STAFF REPORT KETCHUM PLANNING AND ZONING COMMISSION DECEMBER 9, 2025 MEETING

PROJECT: Hotel Riparian Restoration

FILE NUMBER: P25-046

REQUEST: Floodplain Development Permit for major riparian alteration and restoration along Trail Creek.

Figure 4: 2008 Approved Gravel Path

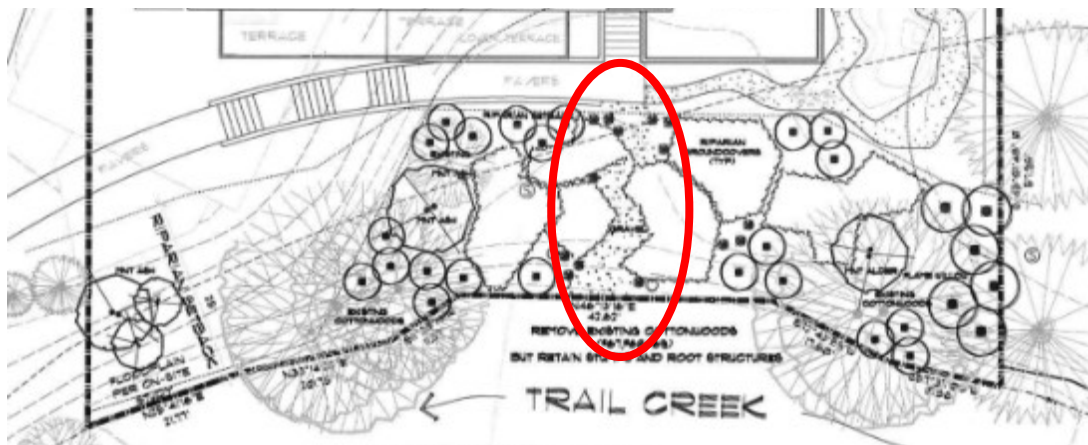
Compliance: This condition of approval was a carry-over from the 2008 PUD/CUP and Design Review approvals. The 2008 approval showed a gravel pathway from the at-grade patio on the south side of the hotel to the water's edge as shown in red in Figure 4 below. As stated in the PUD/CUP documents "Restoration of Trail Creek riparian setback, provision of overlook and trail to creek" were considered special development objectives seen as public benefits that supported the waivers requested by the project in 2008. The purpose of the condition was to ensure that adequate and thoughtful public access be provided through the redevelopment of the subject property.

In an effort to develop a comprehensive restoration plan for the subject property, Planning and Building staff, the City Arborist, and the applicant team conducted a site visit in May 2025. During that visit, it became clear to city staff that the feasibility of providing river access on the hotel property was limited due to access and concerns related to bank stability. The proposed plan includes riparian restoration, and a creek overlook as required, however, staff is recommending an alternative river access location from what was approved in 2008 for the following reasons:

"Water's edge" in the condition of approval implies the mean high-water mark based on the 2008 plans. The bank has significantly eroded over time and there is currently an approximate four to five foot steep drop from the top of the bank to the mean high-water mark. The condition of approval specifies "stone, gravel, decomposed granite, or similar" with limited grading required to achieve the requirement. Either, a detailed grading and drainage plan was not reviewed at the time, or the site conditions between 2008 and today have deteriorated significantly over time. The velocity of water in this location is also higher than other locations along the creek because the creek banks toward the property in this location, increasing likelihood of erosion and increased maintenance demands over time. Staff believe the amount of disturbance and armoring required to provide an access at this location is more extensive than originally anticipated and would require the removal of healthy and established riparian areas to achieve the river access.

Therefore, staff recommends a separate river access be provided on city property adjacent to the Leadville Bridge at Trail Creek at the expense of the applicant. See Figure 5 for the approximate location. This location is near the subject property, provides on-street parking opportunities for fishermen, and requires less disturbance of the bank due to minimal topography change in this location.

Figure 6: 2023 Design Review Approval

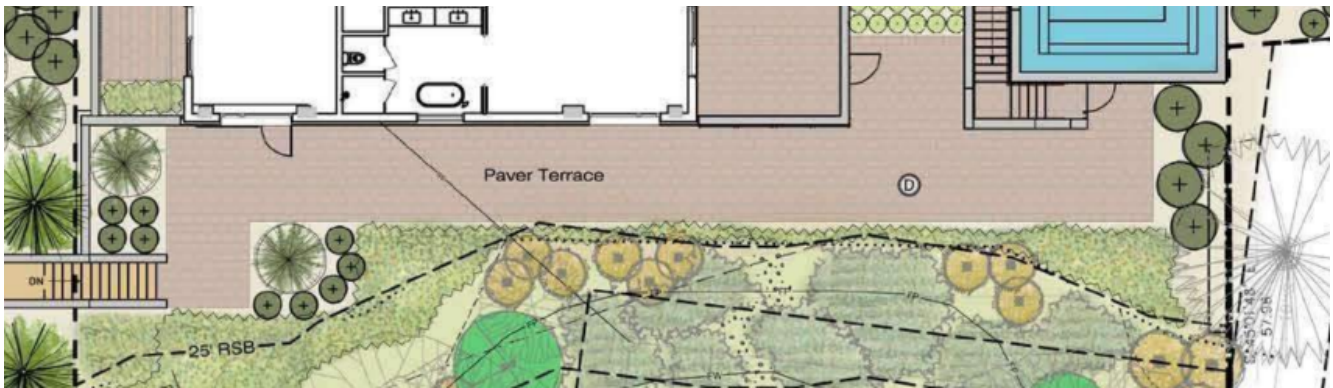
Compliance: The 2023 Design Review approval, shown in Figure 6 below, included an at grade paver terrace almost the full length of the property along the southern end of the building. In Figure 6, the 25-foot riparian setback is the top-most black dashed line noted as "25' RSB". At the time, staff was concerned about the undefined nature of the transition between the paver terrace and the riparian area and recommended condition #15 to address those concerns at a future date.

Figure 7: Proposed Landscape Plan

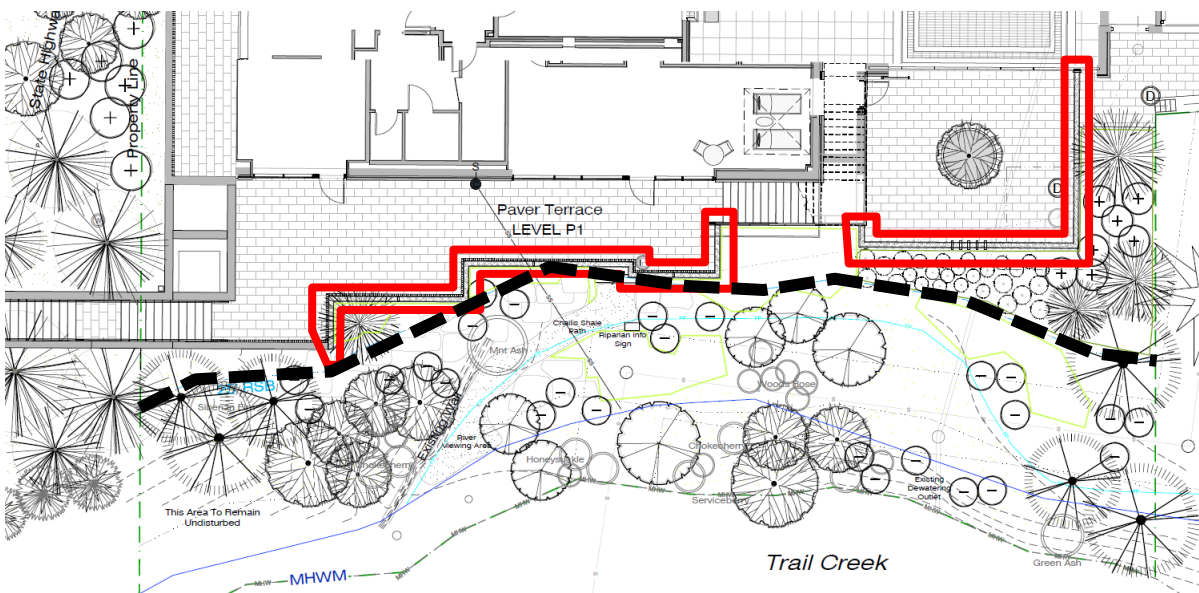
In conjunction with addressing the transition area between the two spaces, as required per the condition, the size and orientation of the paver terrace have been revised. In large part, this was due to changes of the programming of the interior spaces adjacent to the terrace, but it created opportunities to revisit the landscape plan in this area holistically with the riparian restoration work. The revised landscape plan can be found in Attachment B. In Figure 7 below, the revised landscape plan shows the 25-foot riparian setback shown in the black dashed line. The figure also shows the areas of the paver terrace that are at grade and would allow access to the riparian areas without additional protection.

Per the condition of approval, the applicant was required to provide “an appropriate landscaped buffer, signage, and trash receptacles”. The proposed plan includes the revegetation of the riparian area with shrubs, grasses, and trees as the current condition is quite dilapidated along the riparian setback line. Further discussion of the riparian restoration plantings can be found in the floodplain criteria section below. In addition, there is some boulder retaining near the existing retaining wall to ensure slope stability as the riparian area transitions from Hwy 75 toward Leadville Ave.

At the transition between the paver terrace and the riparian area (areas highlighted red in Figure 7) the applicant is proposing a live edge wood louvered fence. The riparian restoration plan also includes additional plantings along the fenceline to reinforce the riparian setback. Figure 8 shows an elevation of the proposed fence treatment. Figure 9 is a section showing the transition between the paver terrace and riparian area at

4. The landscape plan shall be revised to reference plants species from the 2021 Blaine County Wetland and Riparian Plant List and shall be submitted for review and approval by the Planning Department prior to installation of any plant species. Any changes to the approved plant list due to limited availability shall be submitted in writing to the Planning Department and shall be reviewed and approved prior to installation of any plant species.

Figure 10: Trash and Info Sign Locations

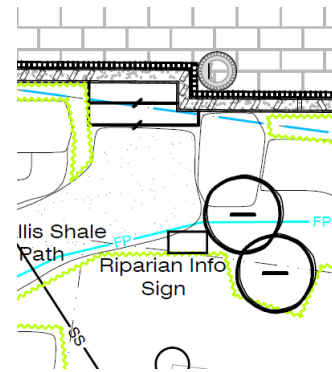
the far northeast end of the paver terrace. Additional sections can be found on Sheet L3.1. Finally, the applicant has placed a trash receptacle and riparian information signage at the entrance to the foot path leading to the creek overlook (see Figure 10).

Staff believe that the proposed improvements meet the requirements of condition 15 of the 2023 Design Review approval. Staff is recommending the Commission require review and approval of riparian information signage content by the Planning and Building Department (condition #5).

5. Prior to commissioning of the riparian information signage, educational content shall be submitted to the Planning Department for review and approval.

Figure 2: 2008 Approved Gravel Path

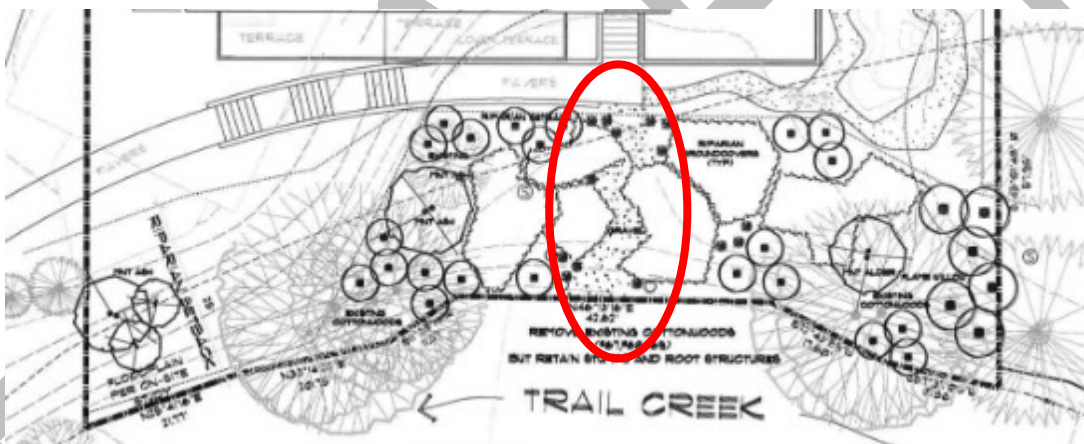
Compliance: This condition of approval was a carry-over from the 2008 PUD/CUP and Design Review approvals. The 2008 approval showed a gravel pathway from the at-grade patio on the south side of the hotel to the water's edge as shown in red in Figure 4 below. As stated in the PUD/CUP documents "Restoration of Trail Creek riparian setback, provision of overlook and trail to creek" were considered special development objectives seen as public benefits that supported the waivers requested by the project in 2008. The purpose of the condition was to ensure that adequate and thoughtful public access be provided through the redevelopment of the subject property.

In an effort to develop a comprehensive restoration plan for the subject property, Planning and Building staff, the City Arborist, and the applicant team conducted a site visit in May 2025. During that visit, it became clear to city staff that the feasibility of providing river access on the hotel property was limited due to access and concerns related to bank stability. The proposed plan includes riparian restoration, and a creek overlook as required, however, the Commission is approving an alternative river access location from what was approved in 2008 for the following reasons:

"Water's edge" in the condition of approval implies the mean high-water mark based on the 2008 plans. The bank has significantly eroded over time and there is currently an approximate four to five foot steep drop from the top of the bank to the mean high-water mark. The condition of

approval specifies “stone, gravel, decomposed granite, or similar” with limited grading required to achieve the requirement. Either, a detailed grading and drainage plan was not reviewed at the time, or the site conditions between 2008 and today have deteriorated significantly over time. The velocity of water in this location is also higher than other locations along the creek because the creek banks toward the property in this location, increasing likelihood of erosion and increased maintenance demands over time. The Commission believe the amount of disturbance and armoring required to provide an access at this location is more extensive than originally anticipated and would require the removal of healthy and established riparian areas to achieve the river access.

Therefore, the Commission approves a separate river access be provided on city property adjacent to the Leadville Bridge at Trail Creek at the expense of the applicant. This location is near the subject property, provides on-street parking opportunities for fishermen, and requires less disturbance of the bank due to minimal topography change in this location. The addition of a river access in this location would increase access opportunities for enjoyment of the creek as the overlook would be accessible from Hwy 75 and the creek access would be accessible from Leadville Ave. The proposed location is where the creek curves to the south where erosion pressure on is on the southern bank of the creek rather than the northern bank, resulting in less erosion issues at the access point than the previously approved location. The city has received two separate bids for the cost of construction of the river access ranging from \$10,000-\$12,000. The city plans to complete the river access in Summer 2026 once peak flow conditions in Trail Creek have subsided. Condition of approval #15 outlines the applicant’s financial obligation for the construction of the access in this location.
